Design Review Board

777 THOMAS STREET | SEATTLE, WASHINGTON

MACFARLANE PARTNERS / ANKROM MOISAN ARCHITECTS, INC.
07.31.2013 DPD PROJECT # 3014045

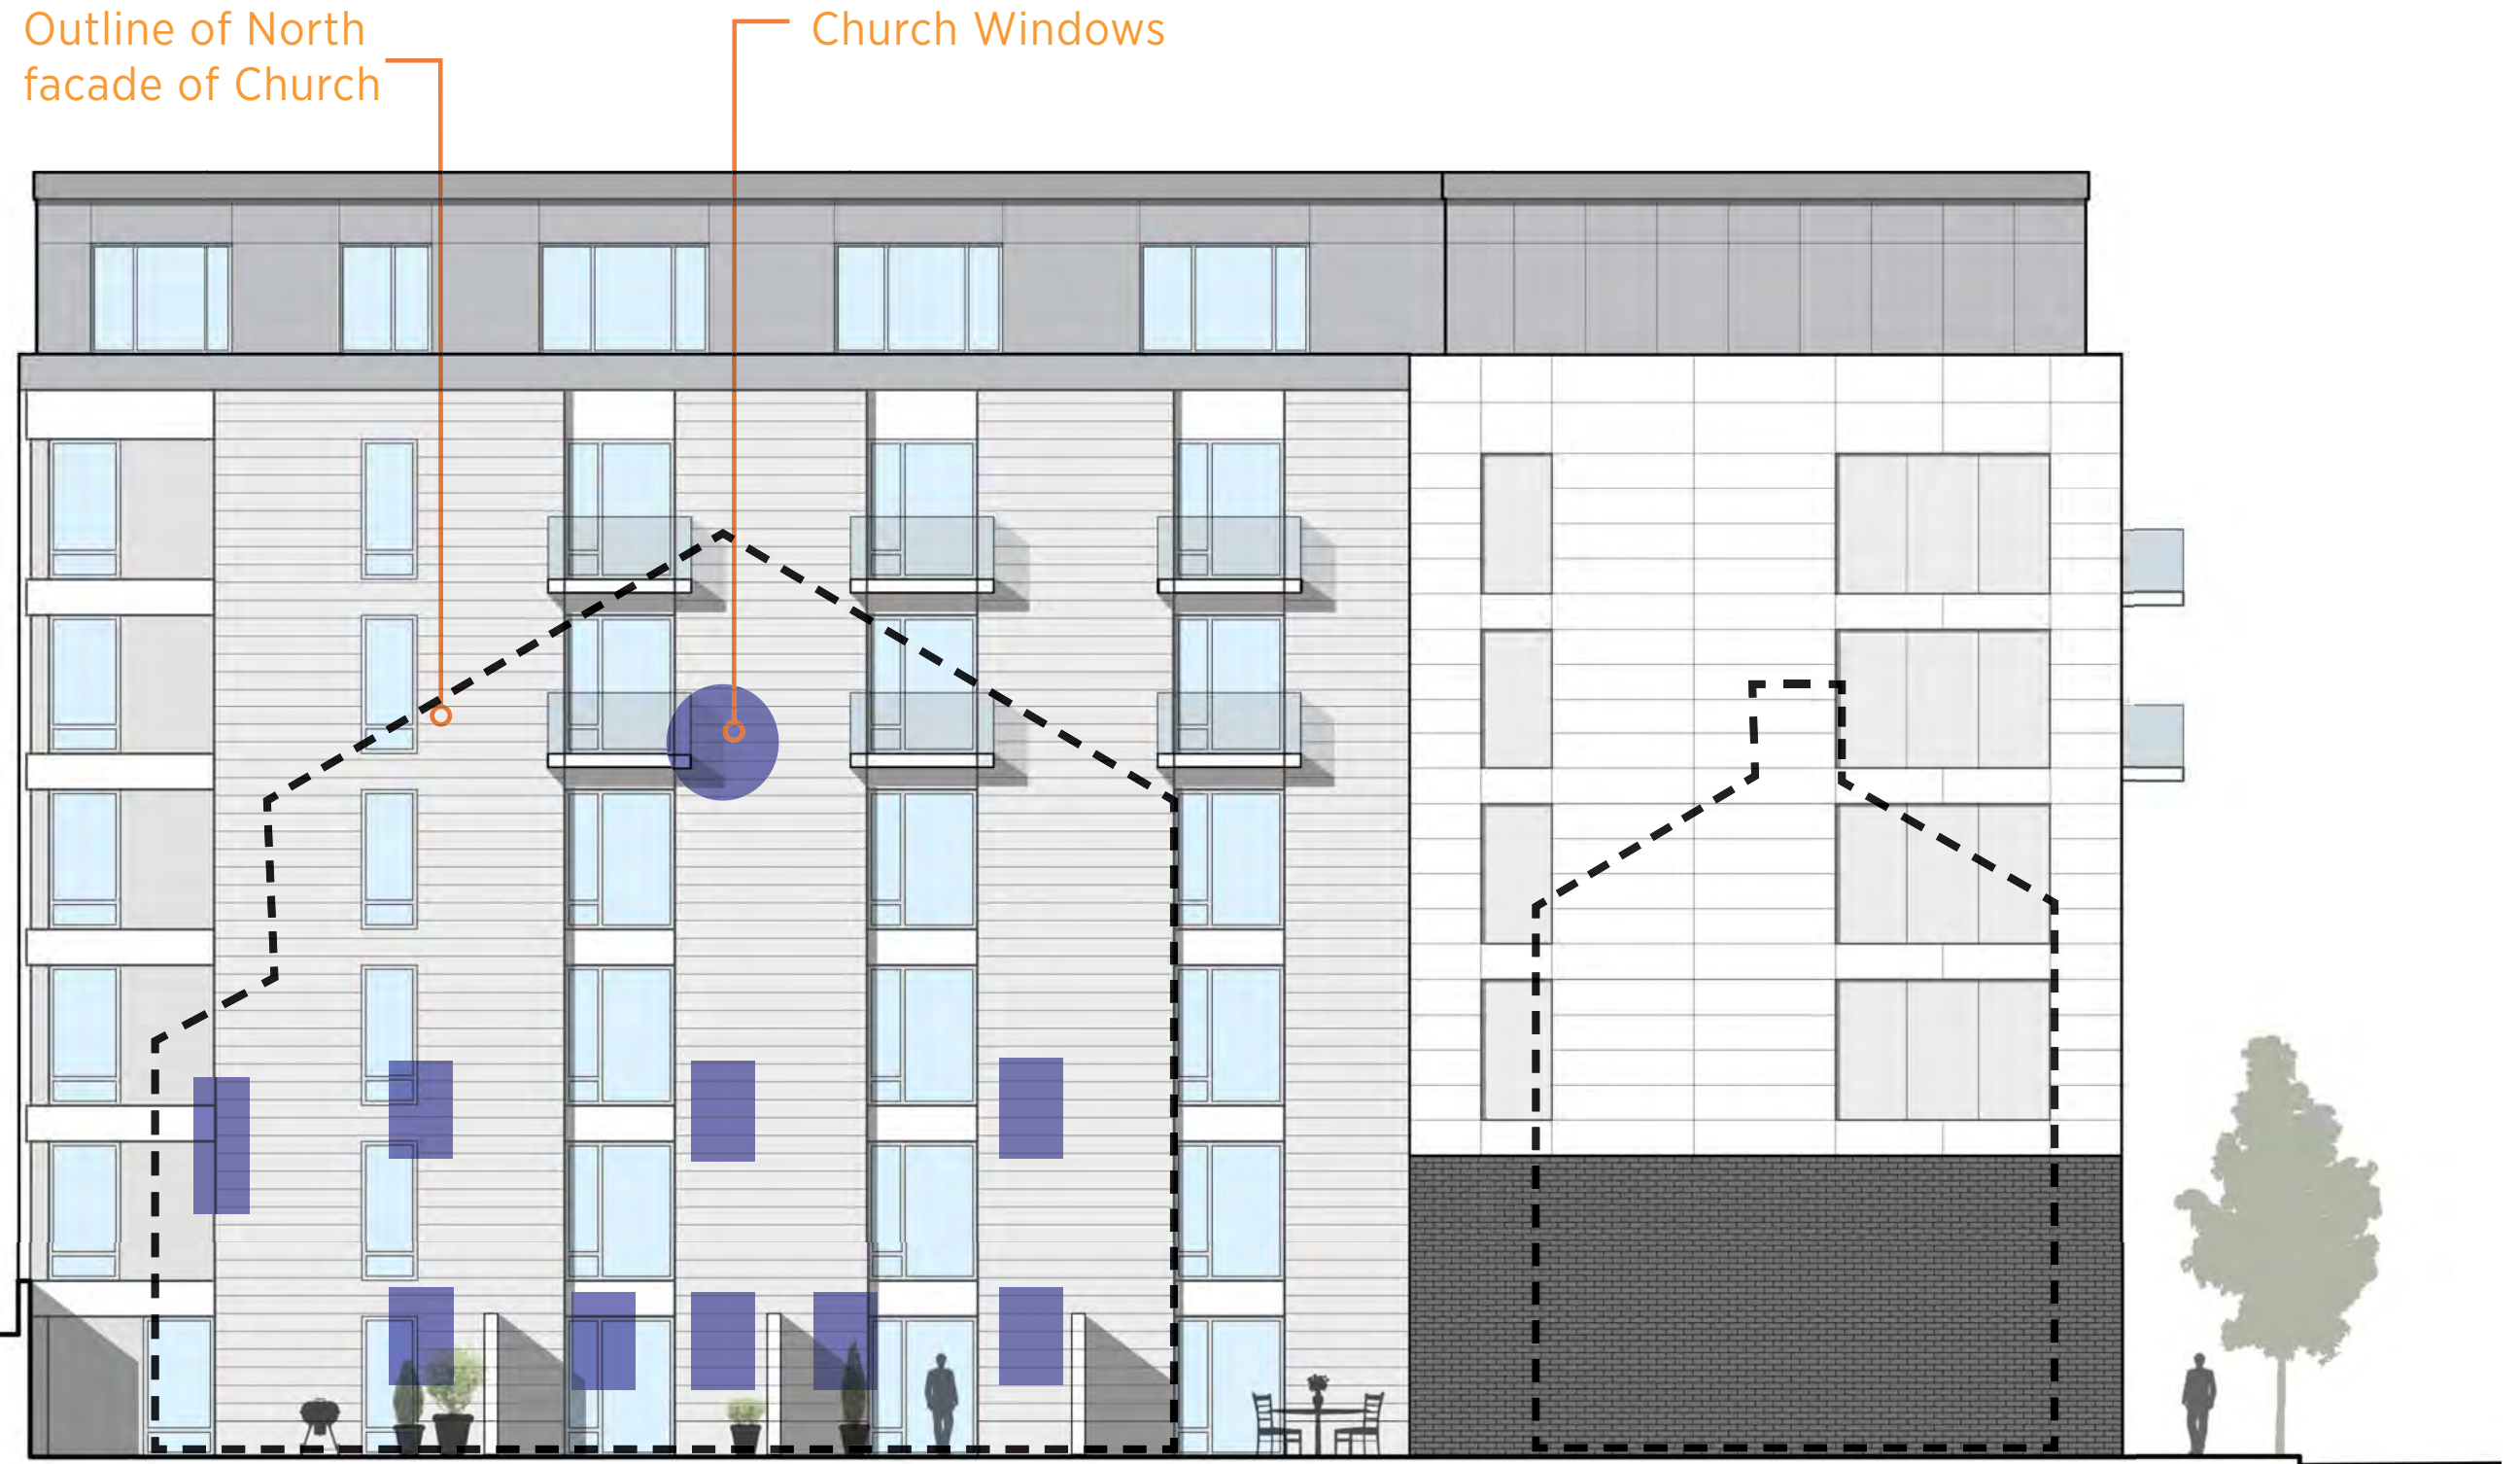
“The landscape plan should be designed to enhance the individual patio areas, rather than linear landscaping that appears to delineate a walkway.”

“... the design of individual terraces, setback, and reflective surfaces is a positive response to the EDG...”

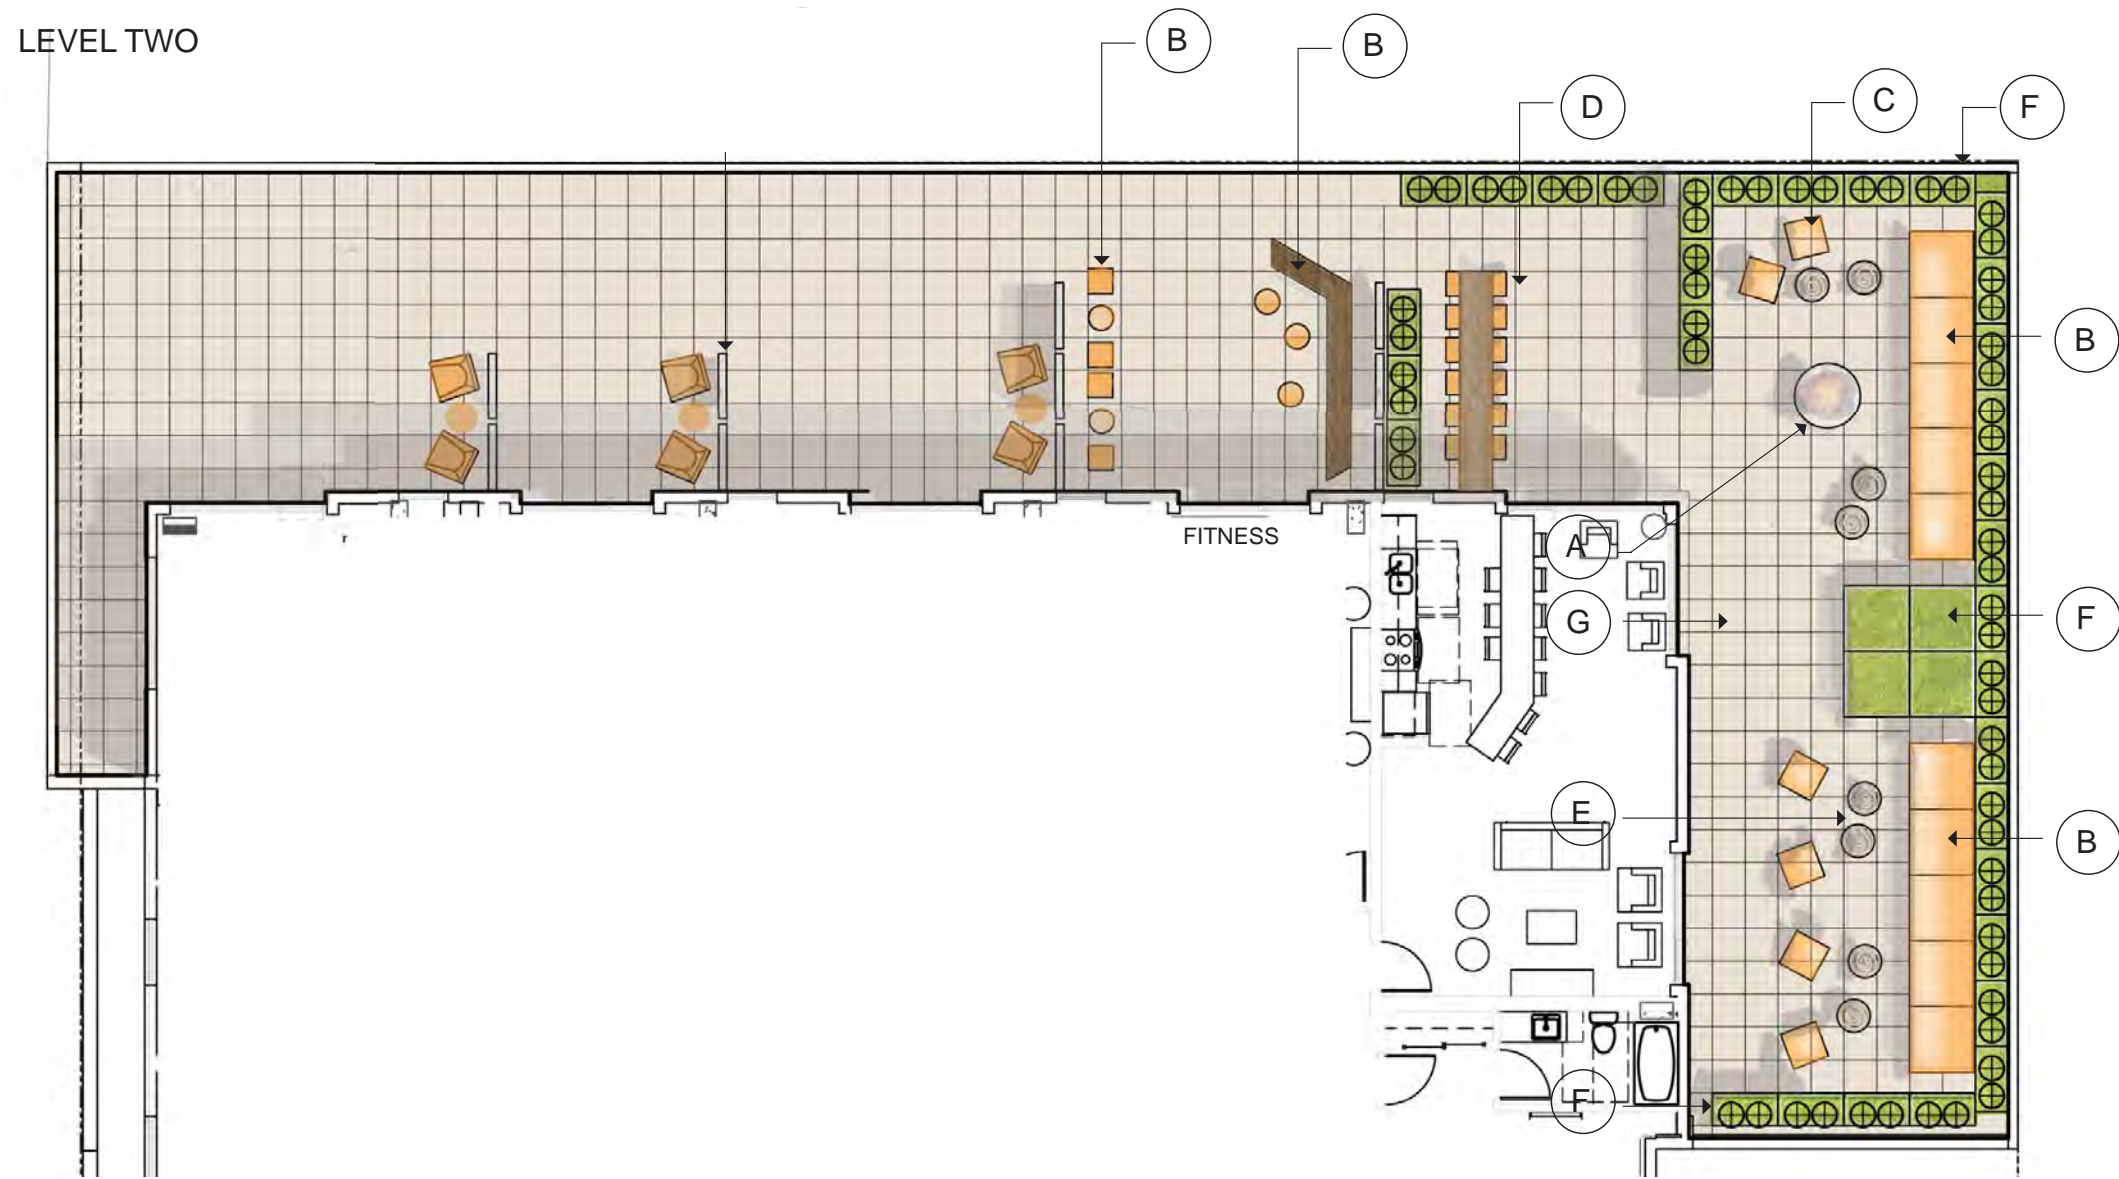
“Uplighting and/or downlighting of the historic structure would be helpful, but the Board noted this would be in the purview of either SDOT or the Landmarks Preservation Board...”

“... the design of individual terraces, setback, and reflective surfaces is a positive response to the EDG...”
Operable rollup doors, lighting, and any other strategies that can help to enhance the commercial viability on Thomas St would be strongly supported by the Board.

DEPARTURE 1: MINIMUM FACADE HEIGHT

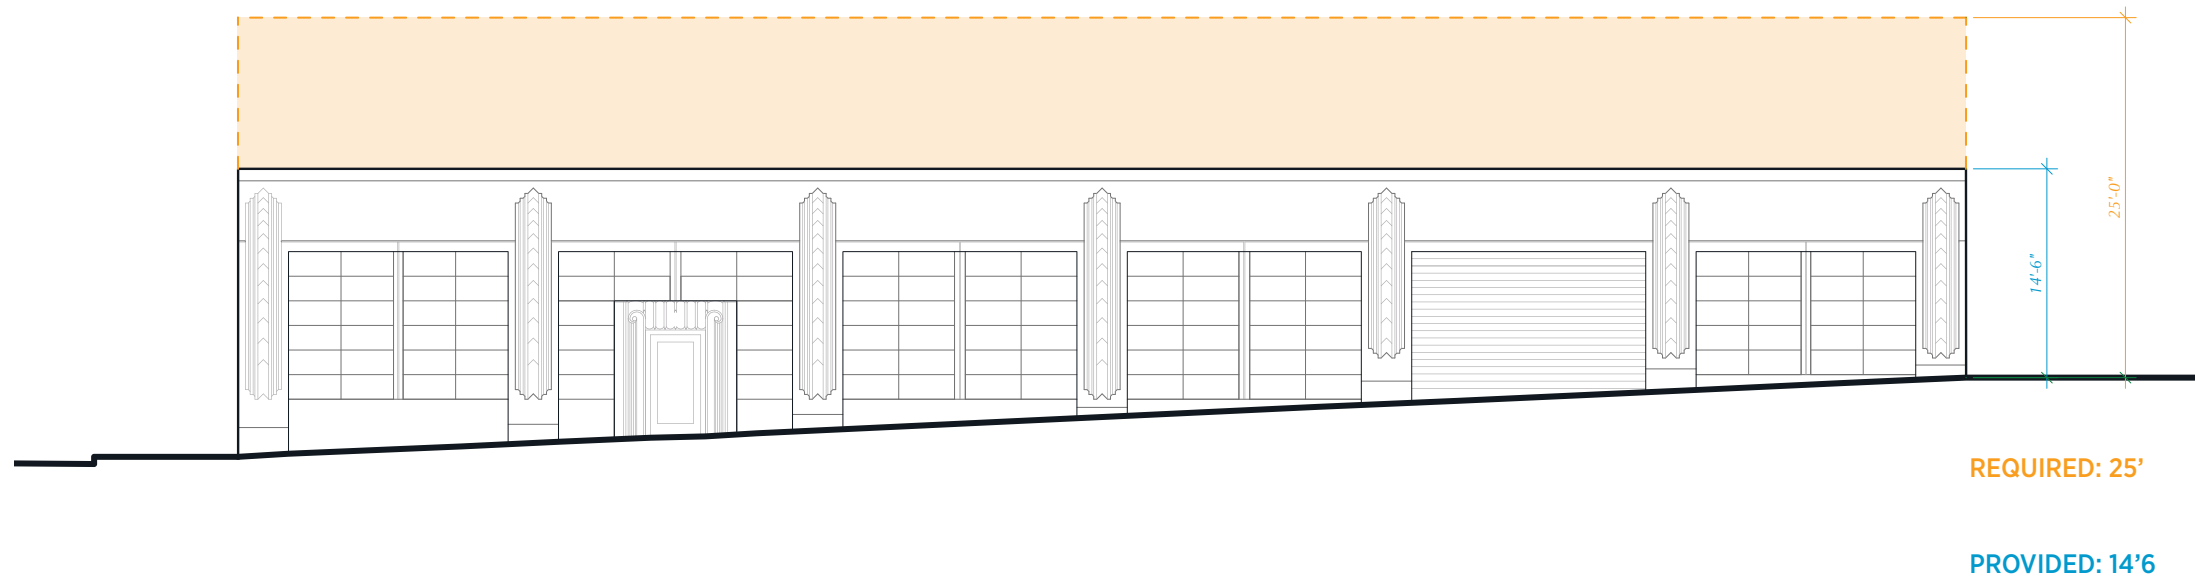
23.48.014B2: MINIMUM FACADE HEIGHTS SHALL NOT APPLY WHEN ALL PORTIONS OF THE STRUCTURE ARE LOWER THAN THE ELEVATION OF THE REQUIRED MINIMUM FACADE HEIGHT LISTED BELOW.

1. ON CLASS 1 PEDESTRIAN STREETS, AS SHOWN ON MAP B, PEDESTRIAN STREET CLASSIFICATIONS, LOCATED AT THE END OF THIS CHAPTER, ALL FACADES SHALL HAVE A MINIMUM HEIGHT OF FORTY-FIVE (45) FEET.
2. ON CLASS 2 PEDESTRIAN STREETS, AS SHOWN ON MAP B, ALL FACADES SHALL HAVE A MINIMUM HEIGHT OF TWENTY-FIVE (25) FEET.
3. ON ALL OTHER STREETS, ALL FACADES SHALL HAVE A MINIMUM HEIGHT OF FIFTEEN (15) FEET.

THE HISTORIC LANDMARKED STRUCTURE FACING THOMAS PROVIDES A MINIMUM FAÇADE HEIGHT OF FOURTEEN FEET SIX INCHES (14'-6). THE DESIGN TEAM PROPOSES TO LEAVE THE HISTORIC STRUCTURE FACADE UNALTERED.

ALLOWING THE LANDMARK'S FAÇADE TO REMAIN UNALTERED HELPS PRESERVE THE NEIGHBORHOOD'S HISTORIC FABRIC.

DEPARTURE 2: FACADE TRANSPARENCY REQUIREMENTS

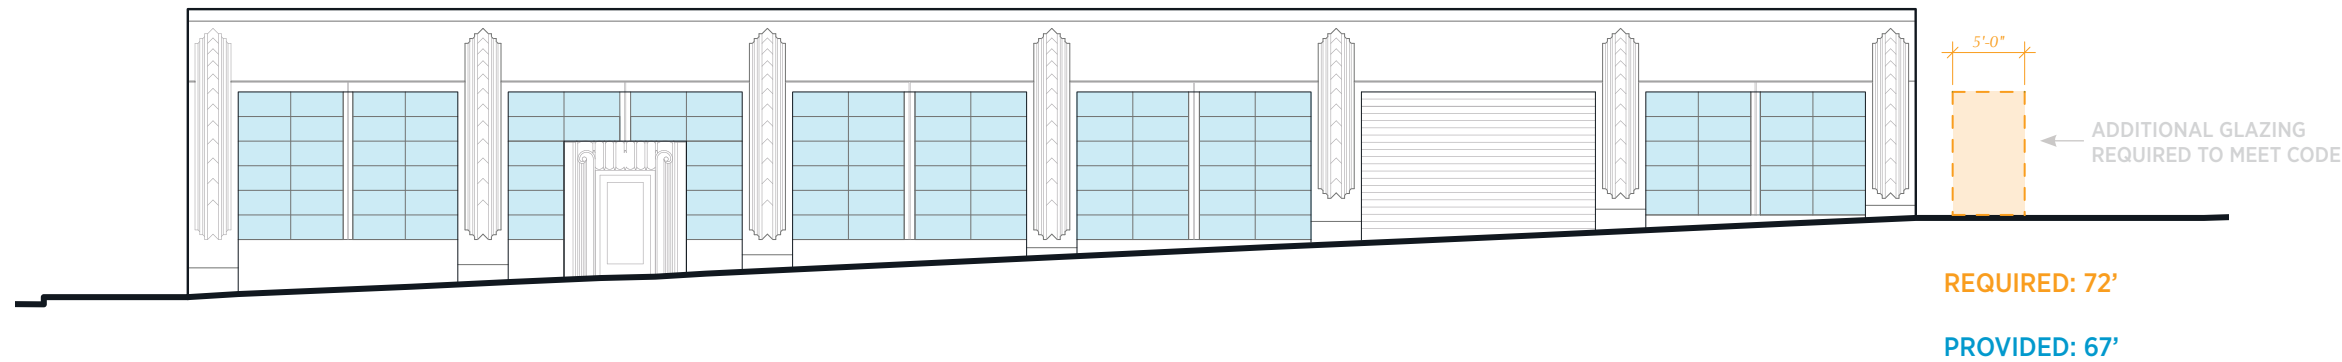
23.48.018A1A: TRANSPARENCY REQUIREMENTS APPLY TO ALL STREET LEVEL FACADES, EXCEPT THAT TRANSPARENCY REQUIREMENTS DO NOT APPLY TO PORTIONS OF STRUCTURES IN RESIDENTIAL USE.

A. CLASS 1 AND 2 PEDESTRIAN STREETS, SHOWN ON MAP B, LOCATED AT THE END OF THIS CHAPTER: A MINIMUM OF SIXTY (60) PERCENT OF THE WIDTH OF THE STREET LEVEL FACADE MUST BE TRANSPARENT.

THE DEVELOPMENT FRONTS A CLASS 2 PEDESTRIAN STREET ALONG THOMAS ST. WHICH REQUIRES A MINIMUM OF 60% OF THE WIDTH OF THE STREET LEVEL FACADE TO BE TRANSPARENT. THE HISTORIC LANDMARKED STRUCTURE FACING THOMAS IS ONLY 56% TRANSPARENT. WE PROPOSE TO LEAVE THE HISTORIC FACADE UNALTERED.

ALLOWING THE LANDMARK'S FAÇADE TO REMAIN UNALTERED HELPS PRESERVE THE NEIGHBORHOOD'S HISTORIC FABRIC.

DEPARTURE 3: BLANK FACADE LIMITS

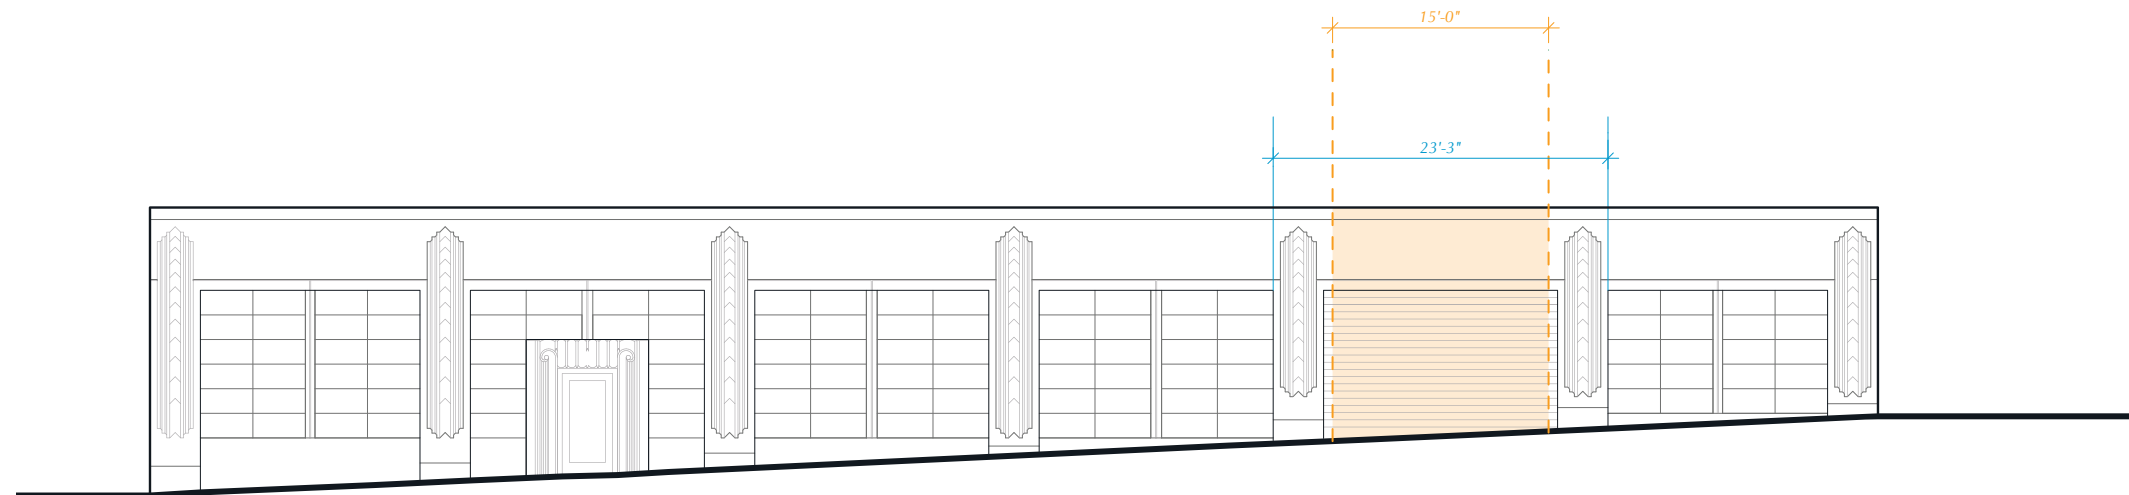
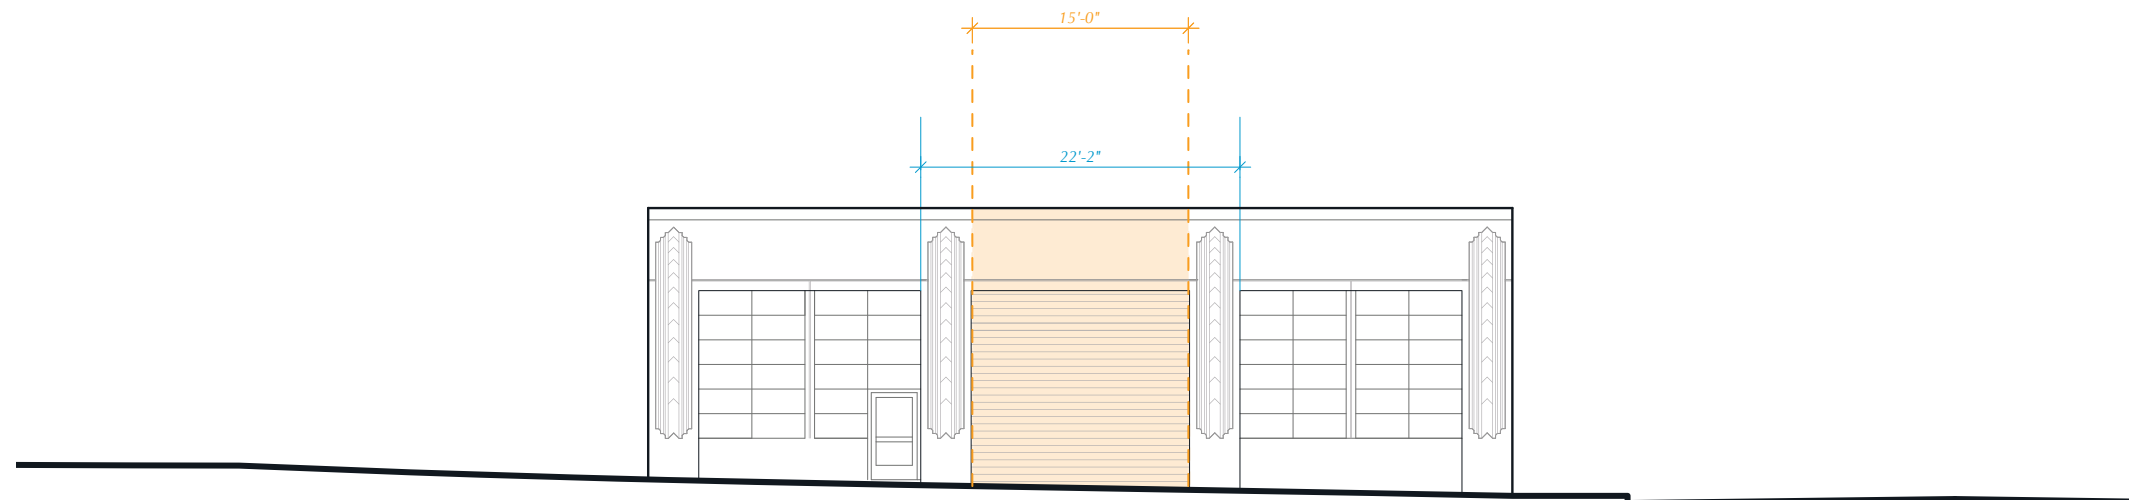
1. ANY PORTION OF THE FACADE WHICH IS NOT TRANSPARENT SHALL BE CONSIDERED TO BE A BLANK FACADE.

2. BLANK FACADE LIMITS FOR CLASS 1 AND 2 PEDESTRIAN STREETS.

A. BLANK FACADES SHALL BE LIMITED TO SEGMENTS FIFTEEN (15) FEET WIDE, EXCEPT FOR GARAGE DOORS WHICH MAY BE WIDER THAN FIFTEEN (15) FEET. BLANK FACADE WIDTH MAY BE INCREASED TO THIRTY (30) FEET IF THE DIRECTOR DETERMINES THAT THE FACADE IS ENHANCED BY ARCHITECTURAL DETAILING, ARTWORK, LANDSCAPING, OR OTHER SIMILAR FEATURES THAT HAVE VISUAL INTEREST. THE WIDTH OF GARAGE DOORS SHALL BE LIMITED TO THE WIDTH OF THE DRIVEWAY PLUS FIVE (5) FEET.

B. ANY BLANK SEGMENTS OF THE FACADE SHALL BE SEPARATED BY TRANSPARENT AREAS AT LEAST TWO (2) FEET WIDE.

THE DEVELOPMENT PROPERTY FRONTS A CLASS 2 PEDESTRIAN STREET ALONG THOMAS ST. CLASS 2 PEDESTRIAN STREETS REQUIRE BLANK FACADES TO BE LIMITED TO SEGMENTS NO LONGER THAN 15 FEET WIDE. THE HISTORIC LANDMARKED STRUCTURE INCLUDES A NON-TRANSPARENT SEGMENT TWENTY TWO FEET TWO INCHES WIDE FACING THOMAS AND A TWENTY TWO FOOT TWO NON-TRANSPARENT SEGMENT FACING 8TH AVENUE. WE PROPOSE TO LEAVE THE HISTORIC FACADE UNALTERED.

ALLOWING THE LANDMARK'S FAÇADE TO REMAIN UNALTERED HELPS PRESERVE THE NEIGHBORHOOD'S HISTORIC FABRIC.
